RAF Brize Norton Airspace Change Proposal

Consultation Feedback Report

Reference	Description
Document Title	RAF Brize Norton Airspace Change Proposal
	Consultation Feedback Report
Document Ref	70751 064
Issue	Issue 1
Date	3 rd October 2018

Figure 5 – GAA Proposed Airspace Design for RAF Brize Norton (and LOA) (Image kindly provided by the GAA)

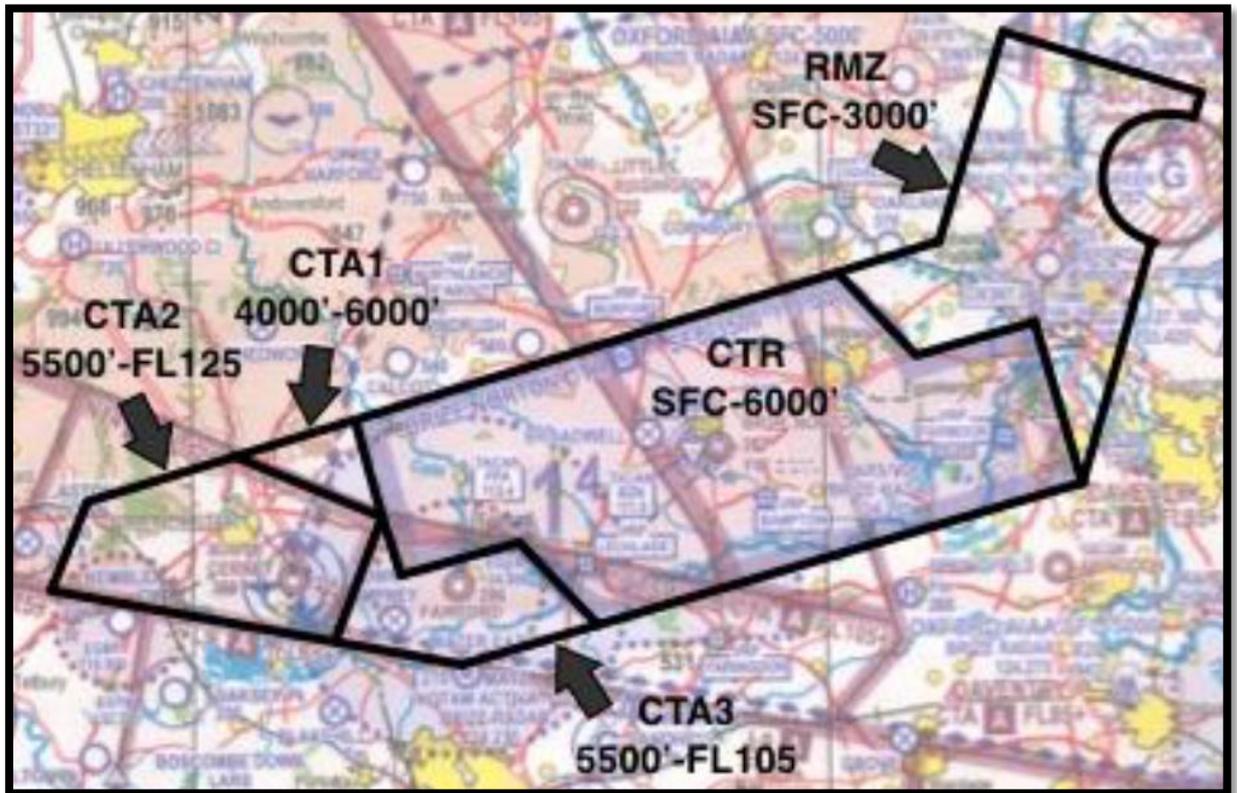
The BHPA support the utilisation of an alternative design proposed by the GAA (detailed in Section 4.3.8) which they consider would allow the current BZN airspace to connect with airway L9 without impacting GA operations.

Whilst the GAA has fundamental concerns regarding the consultation process they did believe that through enhanced engagement it would be possible to meet the needs of the sponsor, the MOD, and other aviation stakeholders, and they provided a proposed airspace design shown in Figure 5 below.

Figure 6 - Consulted CAS Design Concept

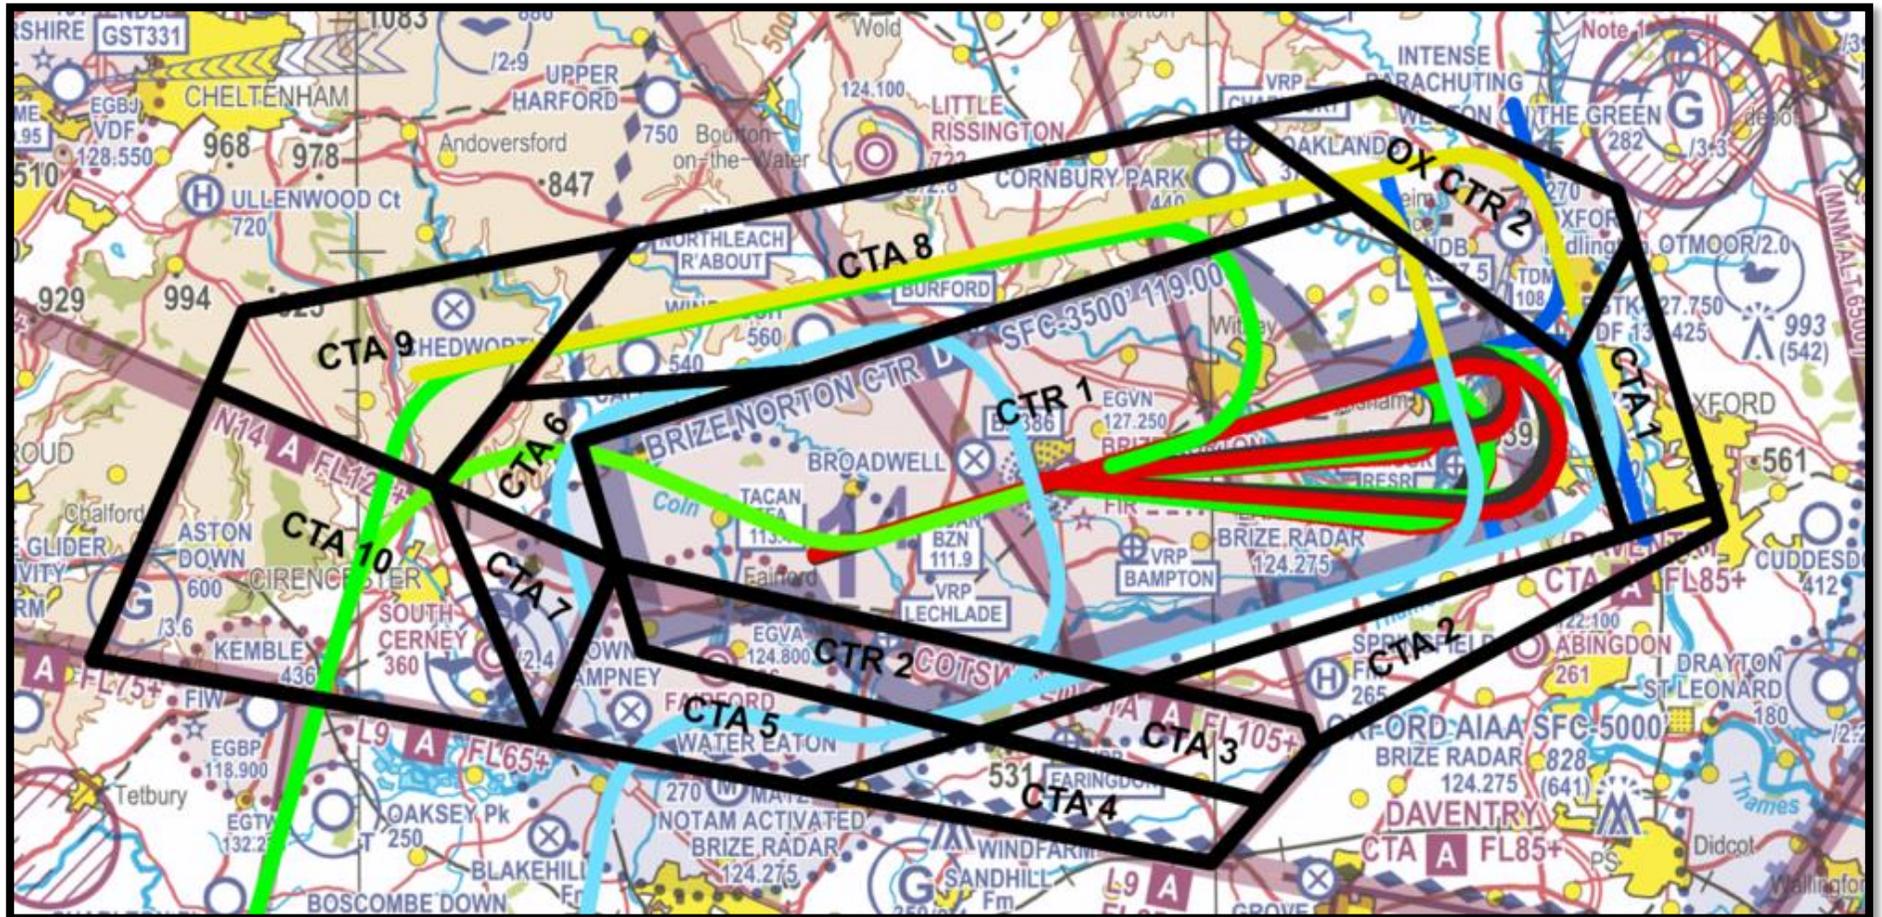
Proposed Solution or Redesign
<ul style="list-style-type: none"> – Raise all CTA bases to 5,000ft.
<ul style="list-style-type: none"> – Resize Brize CTR to contain all military aircraft, give all CTAs a minimum base of at least 3,000ft, remove CTAs 2, 3 and 4 and reduce the size of CTAs 9 and 10.
<ul style="list-style-type: none"> – Set CTA 5 base level to the top level of the Fairford MATZ.
<ul style="list-style-type: none"> – Raise base of CTA 9 & 10 to 5,000 and 6,000; reduce size of CTA 9; CTR1 raised to 6,000ft, remove CTA 5, 6, 7 & CTR2, remove CTA 2,3,4,8.
<ul style="list-style-type: none"> – Reduce the western extent of CTA 9 and 10 to what is necessary for procedures rather than to make the airspace coincidental with existing CAS.
<ul style="list-style-type: none"> – Remove CTA 8 and OX CTA1 and lift CTA 10 to 5,000ft; Raise base of CTA 9 to 5,500ft; reshape CTA1 and 2 so aircraft can pass more easily to the southeast.

Proposed Solution or Redesign
– Raise base of CTA 8, 9 and 10 in light of only occasional use of worst performing aircraft types; move northern edge of CTA 8 to south of Charlbury and Northleach VRPs.
– Increase base of CTA 9 &10 to 5,500ft, reduce the western extent of CTA 9 & 10, move CTA 8 boundary south and raise base to 4,500ft.
– Revise CTA 9 & 10 to allow continued paragliding operations.
– Raise base of CTA 10 to 4,500ft.
– Raise base of CTA 10 to 5,000ft.
– Institute a TMZ instead of CTA 9 &10.

Proposed Change	Summary of Discussion
<ul style="list-style-type: none"> Raise all CTA bases to 5,000ft. 	<p>This change would mean that some of the procedures would not be contained within CAS in accordance with PANS Ops Requirements, however the IFP profiles will be examined to see if the airspace volume can be reduced and still maintain compliance with PANS Ops. This work involves re-assessing climb and descent gradients to ensure that the minimum volume of airspace is required to contain aircraft. BZN is working with the Procedure Designer to understand what may be permissible.</p>
<ul style="list-style-type: none"> Resize Brize CTR to contain all military aircraft, give all CTAs a minimum base of at least 3,000ft, remove CTAs 2, 3 and 4 and reduce the size of CTAs 9 and 10. 	<p>The extent of the airspace required is being closely re-examined in light of the consultation responses, however, it was considered unlikely that all CTA's could be given the same base altitude without increasing the airspace volume proposed. Where reductions in the volume of airspace required are possible, the airspace design will be adjusted accordingly.</p>

<ul style="list-style-type: none"> Set CTA 5 base level to the top level of the Fairford MATZ. 	<p>The rationale behind this request is unclear. IFR arrivals to and departures from RAF Fairford are controlled by RAF Brize Norton Air Traffic Controllers and any access over this area would routinely be handled by RAF Brize Norton.</p>
<ul style="list-style-type: none"> Raise base of CTA 9 & 10 to 5,000 and 6,000ft; reduce size of CTA 9; CTR 1 raised to 6,000ft, remove CTA 5, 6, 7 & CTR 2, remove CTA 2, 3, 4 & 8. 	<p>The RAF Brize Norton flight profiles are being reviewed to determine if steeper approaches are operationally feasible. If steeper approaches are feasible, the volume of CTAs 9 and 10 will be reviewed and reduced in volume where possible.</p> <p>Following a review of the consultation responses, in light of the fact the Long Procedures will not be used frequently, RAF Brize Norton will consider non-containment of the Long Procedures. This will result in the modification or</p>

Proposed Change	Summary of Discussion
	removal of CTA 1 and 2 from the proposed airspace design. This proposal is currently being analysed to see if it is acceptable to the MAA.
<ul style="list-style-type: none"> – Reduce the western extent of CTA 9 and 10 to what is necessary for procedures rather than to make the airspace coincidental with existing CAS. 	See above point.
<ul style="list-style-type: none"> – Remove CTA 8 and OX CTA 1 and lift CTA 10 to 5,000ft; raise base of CTA 9 to 5,500ft; reshape CTA 1 and 2 so aircraft can pass more easily to the southeast 	<p>Following discussions it was considered that CTA 8 is necessary to protect departures from Runway 07 on the MALBY departure profile, however where possible the airspace design team will look to ensure that the minimum airspace volume possible is being proposed to contain RAF Brize Norton procedures and ensure operational flexibility.</p> <p>Following a review of the consultation responses, in light of the fact that the Long Procedures will not be used frequently, RAF Brize Norton will consider the non-containment of the Long Procedures. This will result in the modification or removal CTA 1 and 2 from the proposed airspace design. This proposal is currently being analysed to see if it is acceptable to the MAA.</p>

Proposed Change	Summary of Discussion
– Raise base of CTA 9 to 4,500ft	See above point.
– Raise base of CTA 9 to 5,000ft	See above point.
– Institute a TMZ instead of CTA 9,10	<p>CTAs 9 and 10 adjoin the existing UK Airways network and if the ACP is approved, some of this airspace will be the subject of a Letter of Agreement with NATS to ensure that their procedures are not affected by the adjoining CAS. In order for this agreement to work efficiently, NATS requires assurance that this volume of airspace is a fully 'known traffic environment' particularly if civil aircraft are released to other air traffic control agencies. A TMZ would not provide the same degree of protection or assurance.</p> <p>That said, RAF Brize Norton flight profiles are being reviewed to determine if steeper approaches are operationally feasible in order to reduce the volume of CAS required to contain them.</p>
– Remove the easterly extension of CTR 1.	<p>Following a review of the consultation responses, it has been decided that RAF Brize Norton will consider the non-containment of the Long Procedures. This will result in the modification or removal of CTA 1 and 2 from the proposed airspace design. This proposal is currently being analysed to see if it is acceptable to the MAA. However, CTR 1 is required to safely contain aircraft conducted approaches using the RAF Brize Norton Short Procedures.</p>
